XC2300 Derivatives

16/32-Bit Single-Chip Microcontroller
with 32-Bit Performance
XC2000 Family / Alpha Line

Errata Sheet

V1.9 2014-10

Figure 1 Critical application reset sequence

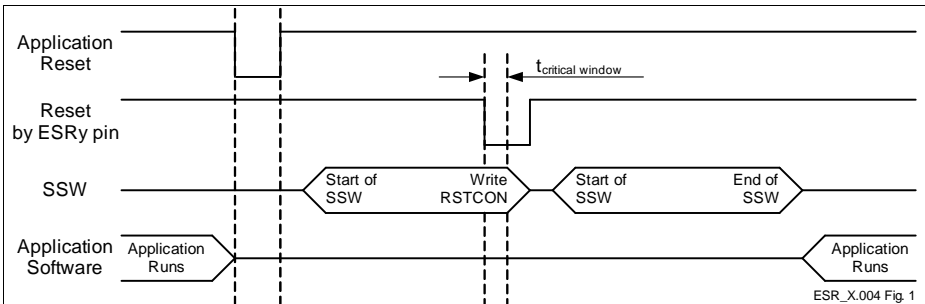
ESR X.004 Wrong Value of SCU_RSTCONx Registers after ESRy Application Reset

SCU_RSTCONx registers are reset only by Power-On, but they may be wrongly affected after a second application reset requested by an ESRy pin. This may lead to the SCU_RSTCONx register values being set to zero, which could unexpectedly disable reset sources within the user application. The conditions which lead to this behavior are:

1. First, an application reset by SW (software), CPU (Central Processing Unit), MP (Memory), WDT (Watchdog Timer) or ESRy (External Service Request y) occurs.
2. Following this, an application reset on an ESRy pin occurs.
3. If the above mentioned ESRy reset occurs during a critical time window of the SSW (startup software), then it's possible that the application will operate with the wrong SCU_RSTCONx register value. The critical time window occurs when the SSW is writing the SCU_RSTCONx registers, and at the same time, the ESRy reset request is processed by the reset circuitry. The width of this critical window $f_{\text{critical window}}$ is less than 13 cycles.

- Initialize `SCU_RSTCONx` registers by user software after any reset, or
- assure that a second application reset request with an ESR pin does not occur during the critical time window.

Figure 2 Example for Case 2: Interrupt Service for Task C delayed

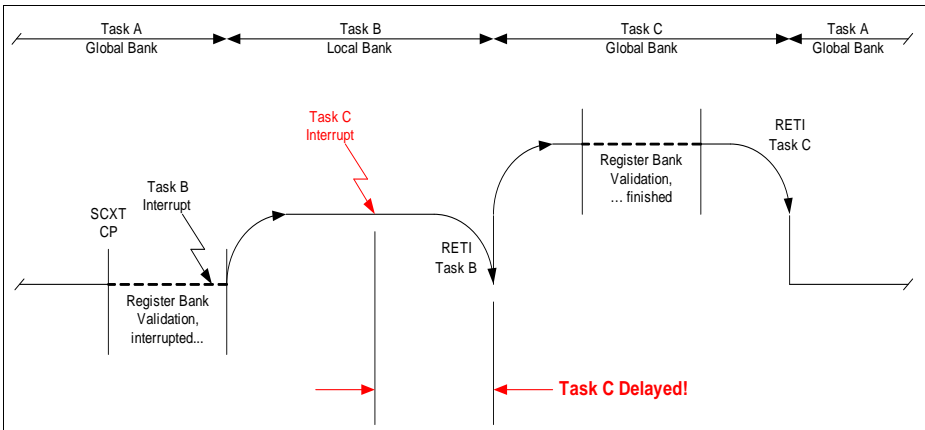
Case 2 (see also Figure 1):

- The Context Pointer CP is written to (e.g. by POP, MOV, SCXT ... instructions) within a routine (Task A) that uses a **global** register bank (bit field PSW.BANK = 00_B), i.e. the context for this routine will be modified,
- This context switch procedure (19 cycles) is interrupted by an interrupt request (Task B) which is programmed (with GPRSELx = 1X_B) to automatically use one of the **local** banks via the bank selection registers BNKSEL0...3 (i.e. the interrupting routine has a priority level ≥ 12),
- Before the corresponding interrupt service routine is finished, another interrupt request (Task C) occurs which is programmed (with GPRSELx = 00_B) to automatically use the **global** bank via the bank selection registers BNKSEL0...3 (i.e. the interrupting routine has a priority level ≥ 13).

In this case service of this interrupt request (for Task C) is delayed until bit field PSW.BANK becomes 00_B after executing the RETI instruction at the end of the routine (Task B) using the local bank.

Workaround for Case 2

When using both local and global register banks via the bank selection registers BNKSEL0...3 for interrupts on levels ≥ 12 , ensure that there is no interrupt using a global register bank that has a higher priority than an interrupt using a local register bank.

Figure 7 External Clock Drive XTAL1

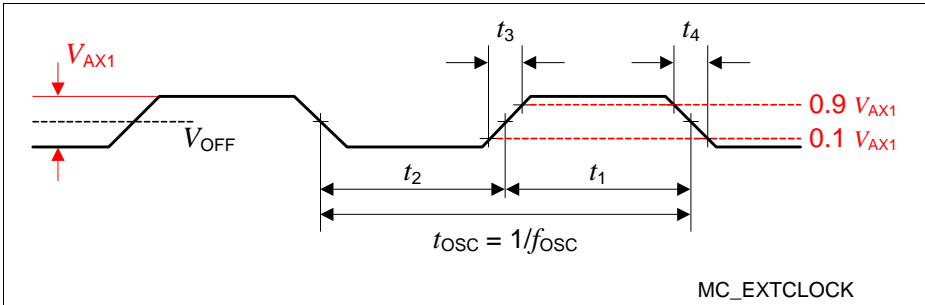
In the Data Sheet section “External Clock Input Parameters” the following table and figure should be updated (major changes are marked **red**).

1) The amplitude voltage V_{AX1} refers to the offset voltage V_{OFF} . This offset voltage must be stable during the operation and the resulting voltage peaks must remain within the limits defined by V_{IX1} .
